October 26, 2024

**Submission of Annual Geotechnical Inspection – 2024, Mary River Project – Nunavut, Project # CA0039374.4332**

## 2024 Geotechnical Inspection Recommendations and Implementation Plan

Figure 32: Section at the upstream side of the main dam (note the detail within the red rectangle at the left, showing an anchor trench into the permafrost). – Source: KM105 Sedimentation Pond Design Brief and Issued for Construction Drawings – Knight Piésold Ltd. 2021

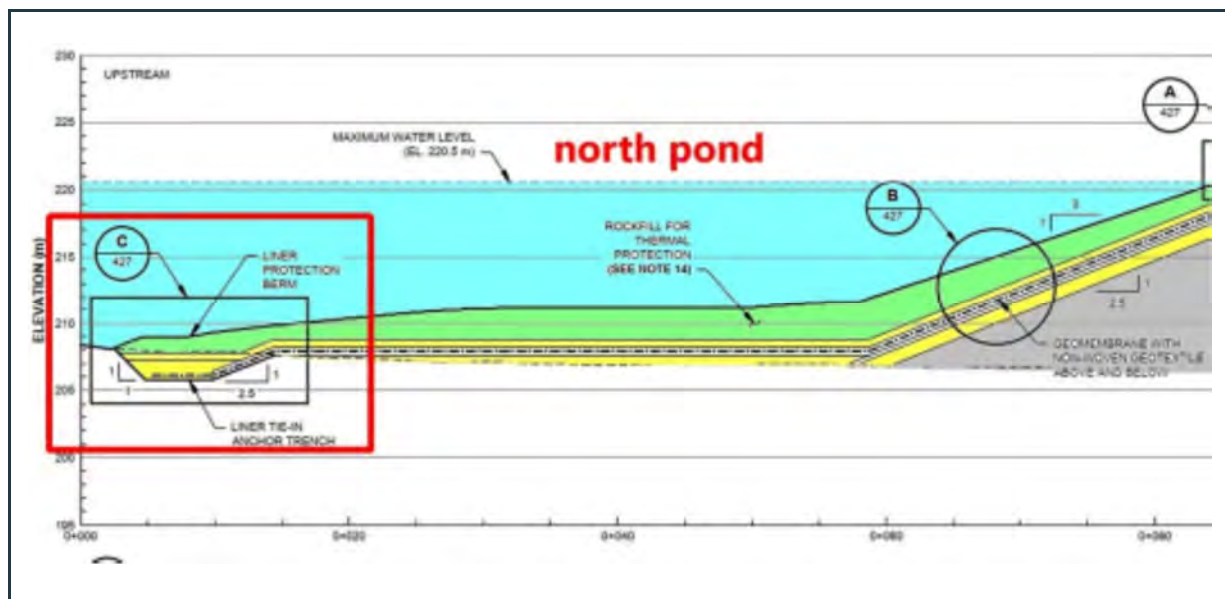
The design of the pond's main dam included an emergency spillway with an invert elevation of 220.5 m, which is the design maximum water level in the MS-11 pond. At normal water level the pond has two separate (but connected) areas: the "north and south ponds", as shown in Figure 4. As specified in the 2021 design, the upstream slopes of the main dam and sections of the side slopes within the north and south ponds (yellow areas in Figure 4) are lined with HDPE geomembrane, placed between two layers of non-woven geotextile, and gravelly sand base and cover layers, and topped with a layer of crushed rock riprap for erosion protection (see Figures 32 and 33).

Figure 34: Section of the side slope in the south pond. – Source: KM105 Sedimentation Pond Design Brief and Issued for Construction Drawings – Knight Piésold Ltd. 2021

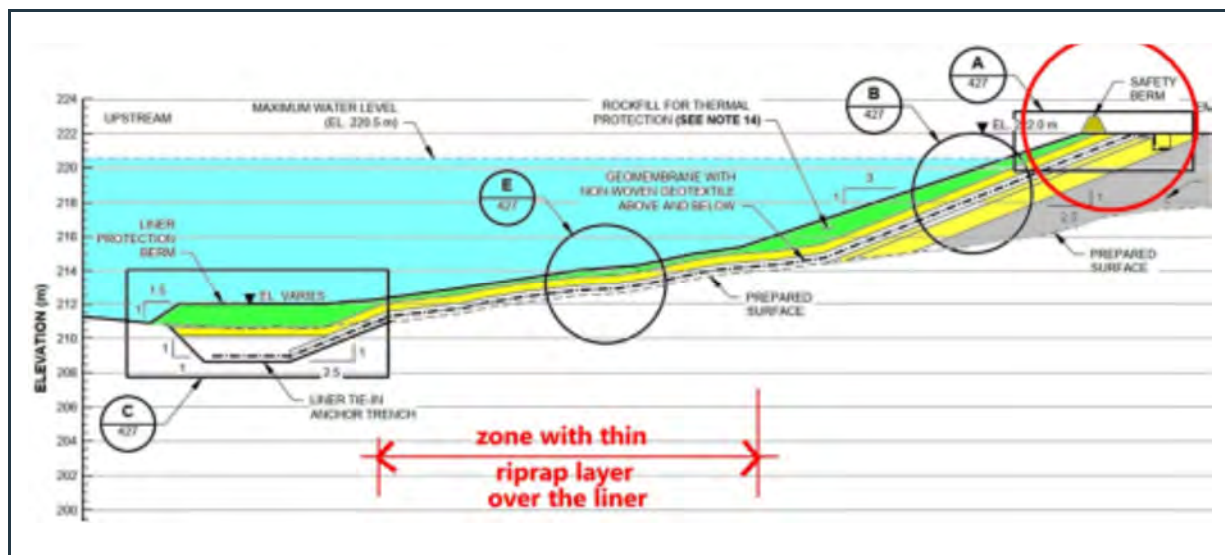
On the side slope of the south pond, the geomembrane liner and non-woven geotextiles extended up to the top of the slope of the embankment and were anchored into an anchor trench at the crest, as shown in Figure 34.

- The other is that one of the safety berms, constructed on the top of the riprap layer, immediately adjacent to the anchor trench at the crest of the embankment (see the red circle in the image). Based on information recently obtained at the mine it appears that during the filling of the ponds with runoff water, around June 11 and 12, 2022, sliding/sloughing of the cover layers and the displacement of the safety berm was noted along the crest of the embankment at the south pond. Figure 35, which was taken on June 22, 2022, shows the slipping (and cracking) of the cover layers (sand and riprap) and the downslope displacement (sliding) of the safety berm just a few weeks after the completion of the construction and during the early stage of filling the pond with water.

Figure 36 was taken during the recent site visit on August 26, 2024, which shows that the liner beneath the cover layers is still intact and anchored into the anchor trench at the top of the embankment's slope. This indicates that only the cover layers and the safety berm have moved (slipped) in June 2022, and that there was no "classical" slope failure within the embankment at the south pond. It appears that the embankment beneath the liner is stable, and the anchor trench is still at its original position along the edge of the crest (at road level), still supporting the liner as per the original design.

Figure 41: Satellite view of the solid waste landfill facility and the adjacent two, recently constructed landfarm cells (1 and 2). Cell 3 is proposed for construction in the future.

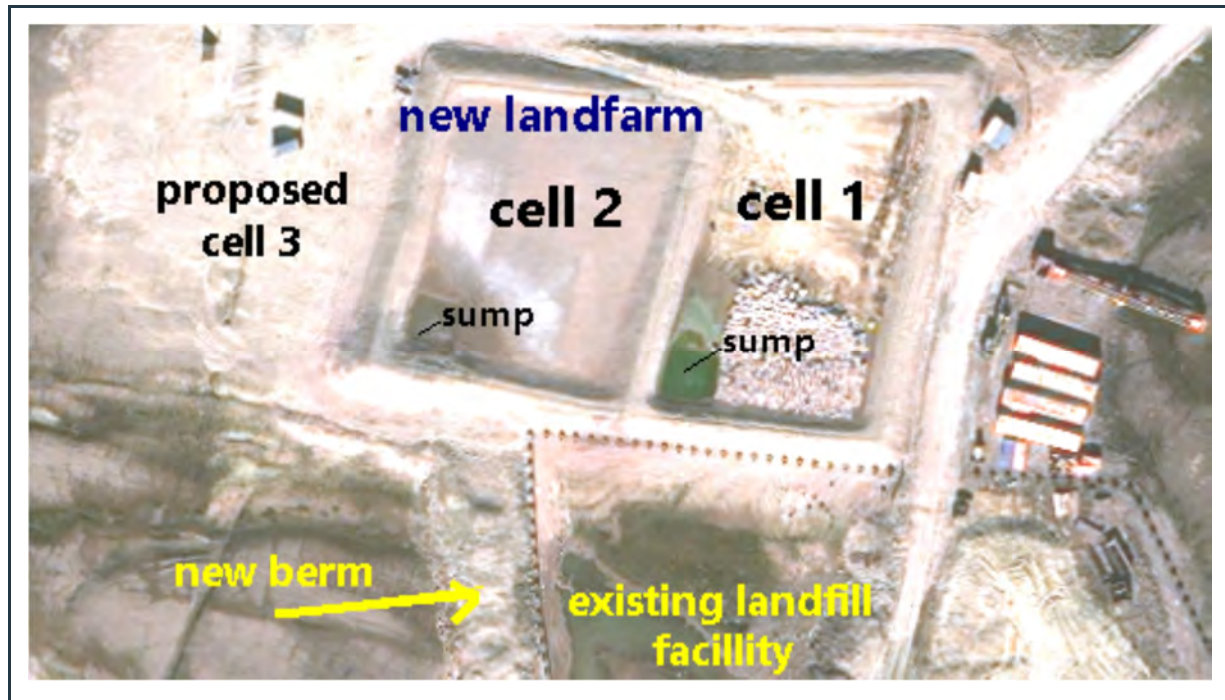
The non-hazardous solid waste disposal area is in the southern zone of the Mary River Mine site, as shown in Figure 6. Two (2) new landfarm cells were constructed near the gate of the main landfill facility, as shown in Figure 41. It is understood that the number of new landfarm cells may be increased to three (3) as shown in the image.

Figure 44: View of the stable berm around the currently empty cell-2 of the new landfarm. The ponding water indicates good liner performance. Note that the water should be removed prior to storing any material in this cell.

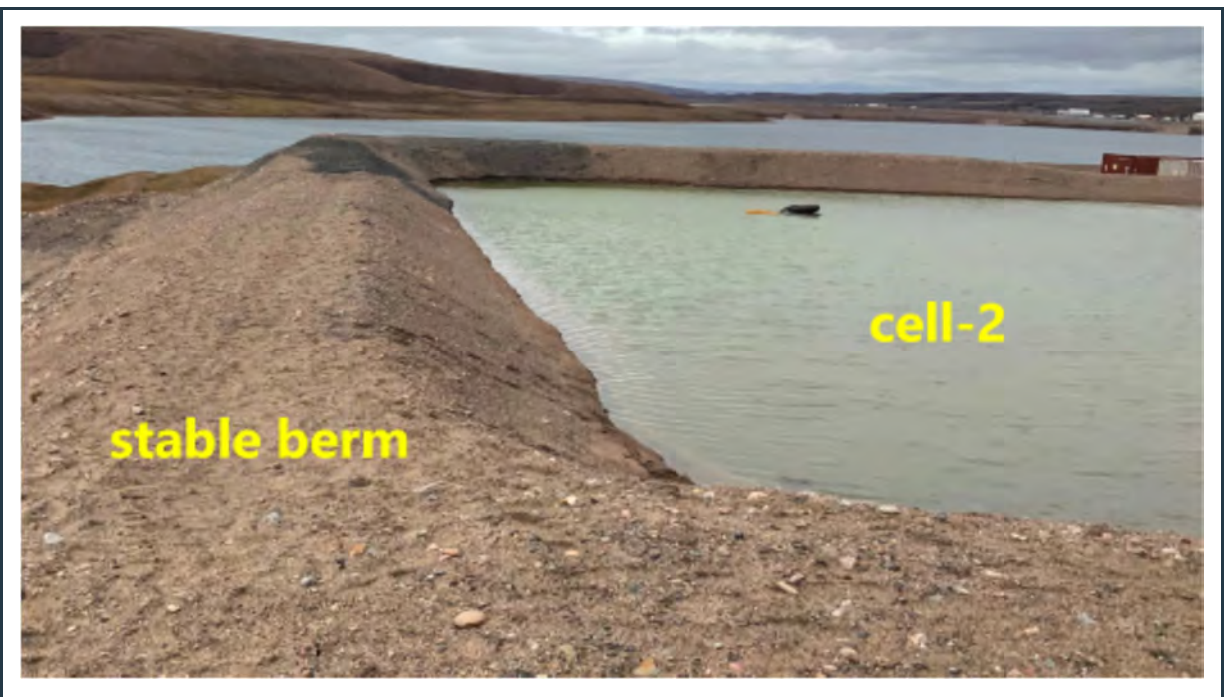
Figures 43 and 44 show the robust stable berms around the cells. During the August 2024 inspection it was noted that the currently empty cell #2 had lots of ponding water within the cell. This indicates good liner performance; however, the water should be removed and properly disposed, prior to storing any material within the cell.

Figure 54: View of the sump and emergency spillway at the back of the HWB-1 cell with stable berm.

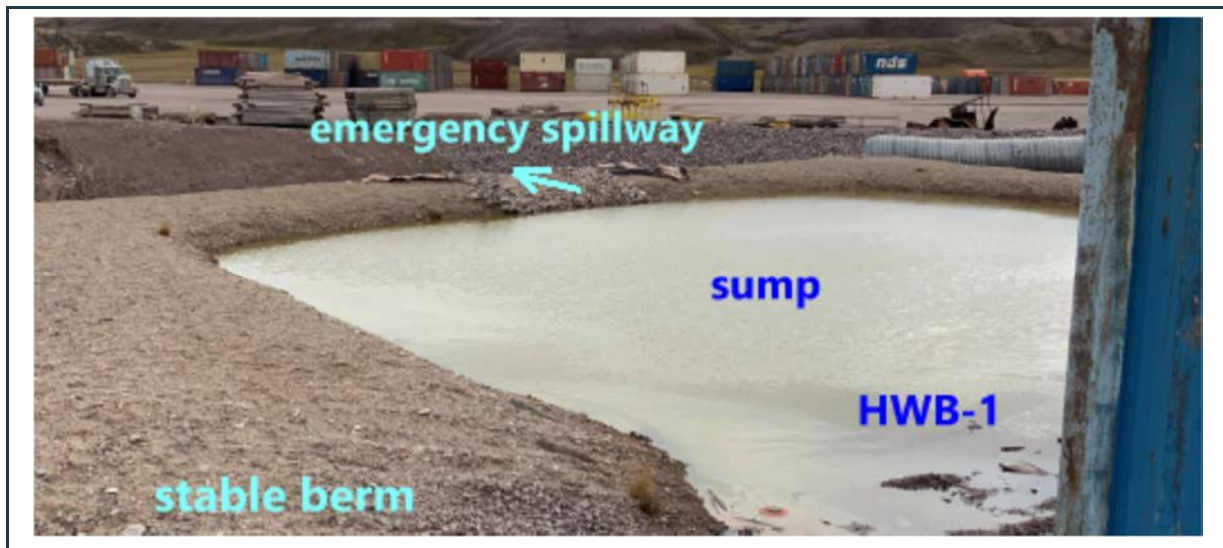
The HWB-1 is the largest cell of the four, bounded by stable perimeter berm, constructed of thaw-stable granular soils, as shown in Figures 53 and 54, in Appendix B. Two shipping containers, fuel barrels and other materials are stored in the cell generally on wooden pallets, as shown in Figure 53. Ponding water was visible in the rear sump area of the cell (Figure 54), indicating that the liner within the cell is intact and working as intended. No seepage from the cell was visible around the downstream toe of the perimeter berm and the granular fill, covering and protecting the liner across the cell's interior, is well maintained. Materials on pallets should be stored within the cell, not on the berms (note the container marked by the blue arrow in Figure 3, that should be moved from the berm's slope into the cell).

Figure 87: View of the Western Globe Fuel Module (WGFM) north of the 380 Camp. No humps are visible at the entrance and exit points of the refueling station.

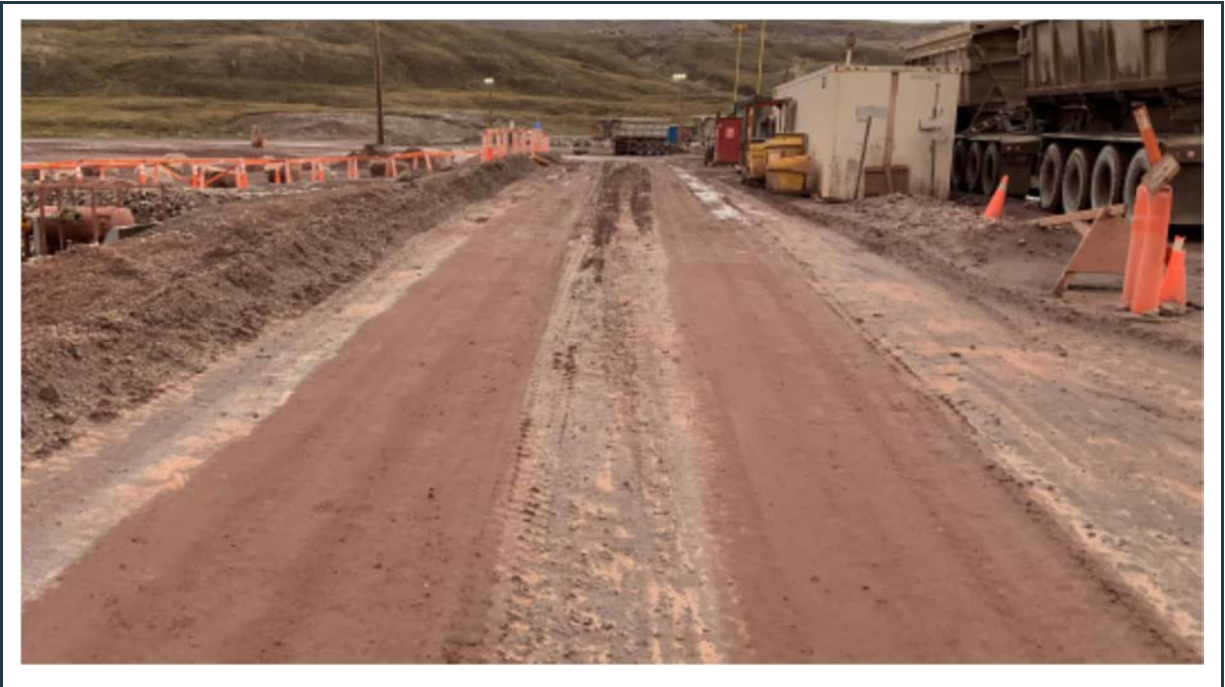
The Western Globe Fuel Module (WGFM), shown in Figure 87, is located north of the 380 Camp. As opposed to design specifications, no humps are visible at the entry and exit points of the refueling station. The top image of Figure 88 presents part of a historic design drawing (drawing number C01), showing a section of a 900 mm wide (at its crest) and 450 mm high drainage control hump with 10H:1V slopes, specified by B.H. Martin Consulting Engineer and Architect in June 2016. The purpose of the humps at the entry and exit points of the refueling station was to prevent oily surface water escaping the refueling area. As shown in the top image of Figure 88 the entire area of the refueling station has a liner beneath the road fill, which liner should also have a 10H:1V slope up to the internal edge of the 900 mm wide humps. Under the heavy truck traffic at the station; however, those humps were flattened/spread in the past but shall be reinstated. It is suggested that the edges of the liner beneath the road fill be exposed using hydrovac, and the humps reconstructed as designed. In addition, installation of timber beams is suggested within the humps, to prevent the flattening of the granular fill by the heavy trucks in the future, as shown in the lower image of Figure 88.

Figure 102: View of the outlet of the culvert at KM 32+900. The ditch at the front of the culvert should be cleaned from the sediment during culvert replacement, and more riprap should be placed.

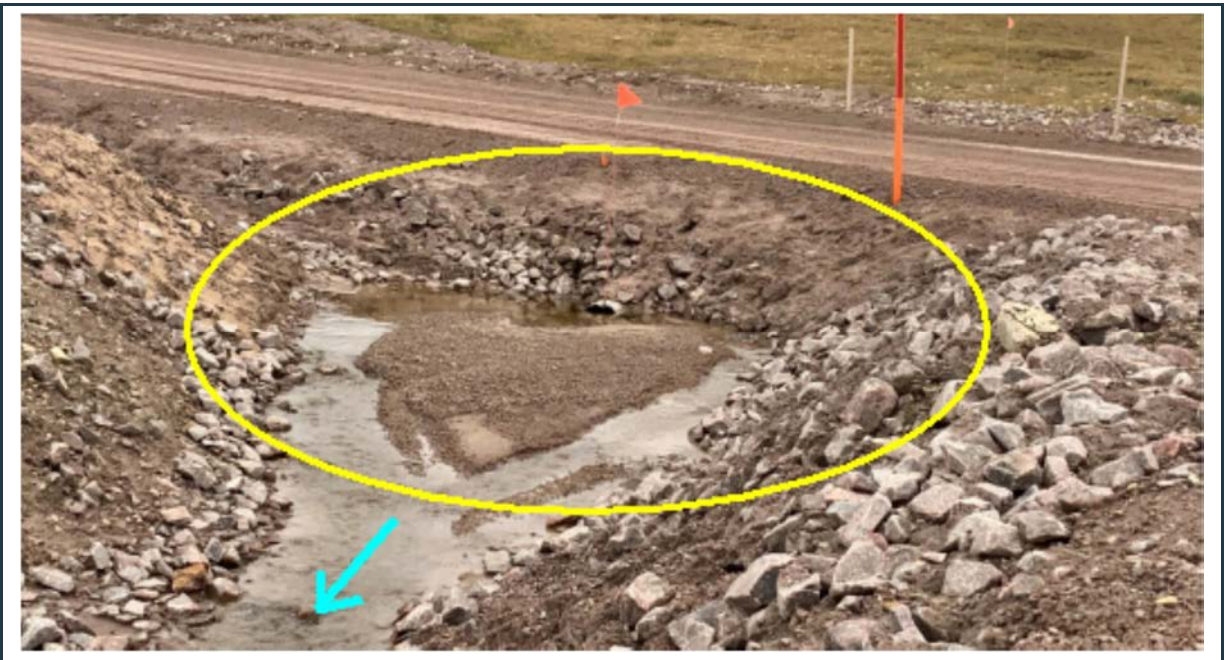
Buildup of fine sediment is visible at the entrance to the culvert, potentially clogging the corrugated pipe. The image in Figure 102 also shows large quantity of finer soils (silt and fine sand), deposited at the front of the pipe's outlet. To provide uninterrupted flow, the culvert should be cleaned or replaced with a longer pipe as soon as practically possible. More rockfill should also be placed around the culvert's inlet, while the silt, deposited at the front of its outlet, should also be removed (Figure 102). The crest of the nearby check-dams (Figure 103), show some loss of rock fill. The dams should therefore be raised by placing additional rock fill on their crests, and the ditch behind the dams should be cleaned (fine soil removed).

Figure 112: View of the inlet of three culverts at KM 90+100. Only one (green arrow) is operational.

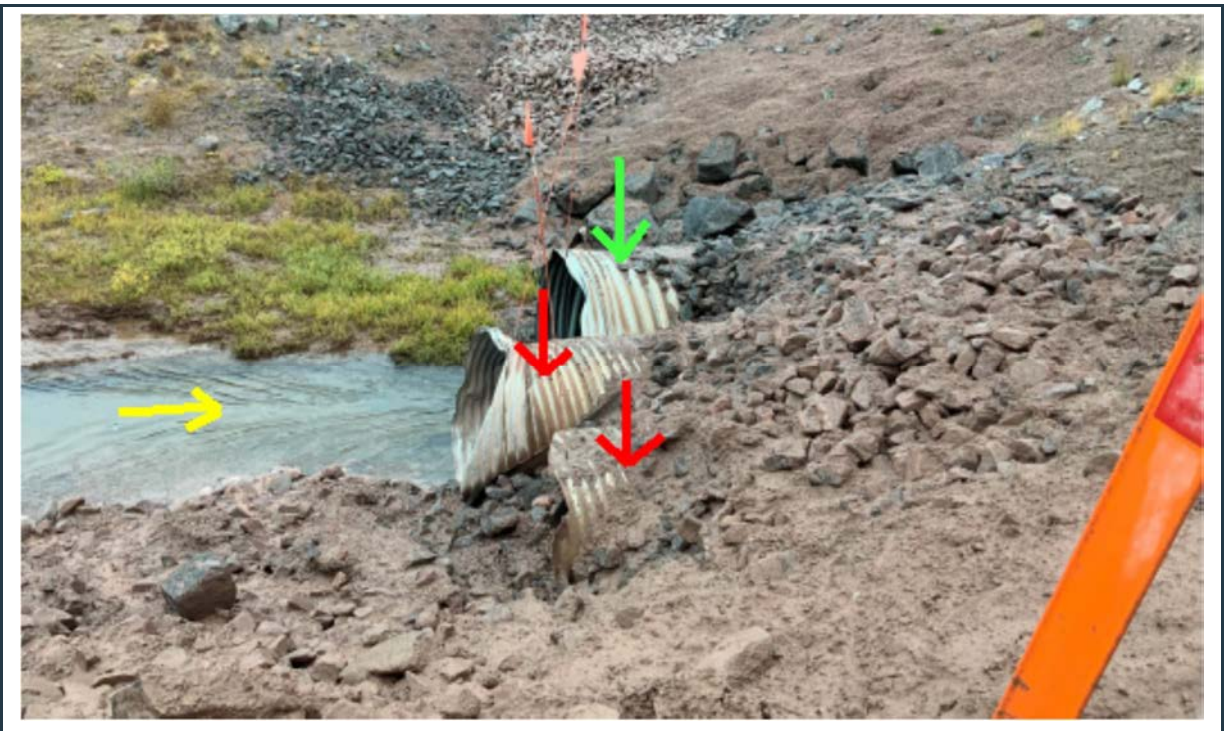
Figures 112 and 113 show the inlet and outlet of three corrugated pipe culverts, one relatively new (green arrow) and two old (red arrows) pipes. As shown in the images, only one of the three pipes is operational. Figure 113 also shows that the operational (green arrow) pipe is not perpendicular to the road, but follows the alignment of the stream, crossing the road at an angle (skewed barrel). Such culvert alignment may often result in increased erosion of the road embankment at the inlet and outlet ends of the culverts (note the yellow circle in Figure 113). It is suggested to closely monitor the embankment at both ends of this culvert and make appropriate steps (if needed) to prevent sloughing of the material at the toe of the road embankment, by lengthening the culvert at both ends, and by placement of additional riprap on the adjacent embankment slopes, particularly at the toe.
